Design Code Stakeholder Comments as of February 16, 2024

Metal, No Window Trim

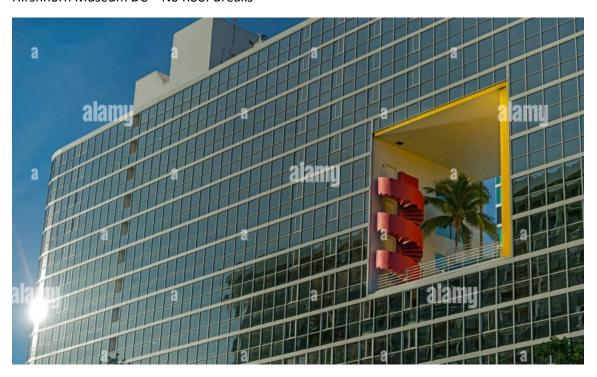
I believe dictating or limiting materials is not going to be very effective to achieve the desired outcome the county is looking for. There are many great examples of stunning architecture that use "smooth-faced concrete block or other smooth-faced finishes", and using only one material, texture or finish. I believe the wording is a bit ambiguous. Do Frank Ghery's or Tadao Ando's smooth facades fall into this category as some of their buildings only use one material. See sample photos.

Prohibiting metallic facades is also not recommended. Metal is a great exterior material for our climate. It sheds water better, reflects heat better, and lasts longer than most standard materials. I actually wrapped my entire house in corrugated metal for these reasons. There are many different textures and patterns of metal siding. See sample photos.

I have attached some photos of existing buildings that may not be permitted if these codes are approved as is.
